**Draft Safety Requirements:**  
**(DS543) Regulations for the Safe Transport of Radioactive Material, 20XX Edition**  
**Comments on Step 11 Draft dated 23 Aug 2024**

COMMENTS BY REVIEWER Country/Organization: Argentina-TRANSSC, Canada-TRANSSC, China-NUSSC, France-RASSC, France-TRANSSC, Germany-TRANSSC, India-NUSSC, Indonesia-EPRcSC, Japan-RASSC, Japan-TRANSSC, Morocco-TRANSSC, Switzerland-TRANSSC, UK-TRANSSC, USA-TRANSSC, WNTI				RESOLUTION

Table 10.5. Typical values for skin mass thickness

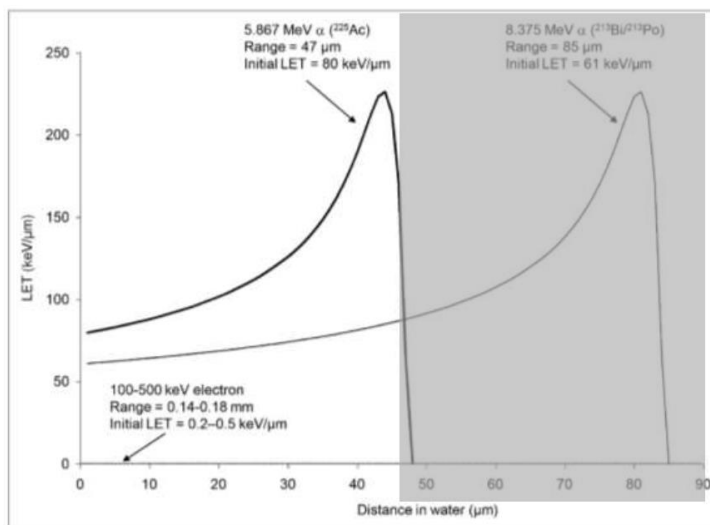
*This comment is referring to figure 10.3 [of ICRP 89] which is indirectly called by para. 517 and is derived from a 1973 publication. This figure likely explains why you get two kinds of contamination dose in RP65 (at depth of 400 and 40 µm for beta radiations, depending on the localisation of the contamination; this is already 70 µm for gamma/X radiations – those considerations are based on Charles (1986), Kocher & Eckennann (1987) and Chaptinel et al. (1988) publications). There are many things to say about that figure :*

- The contamination model indeed considers that hands are the most likely part of the body that gets contaminated, but I am not sure that, while you manipulate debris and such, you won't get contaminated elsewhere, especially the back of your hand (for which fig. 10.3 says thickness is around 100  $\mu\text{m}$ , if reference to it had to be done) or your face (50  $\mu\text{m}$ ) through inadvertent movements: those behaviours were heavily documented during the COVID period. Eventually, resuspension also leads to superficial contamination. That said, I admit that the transmission fractions from hand palm to those areas may be less than the overall  $10^{-5}$  fraction considered in the  $Q_{D,skin}$  scenario.
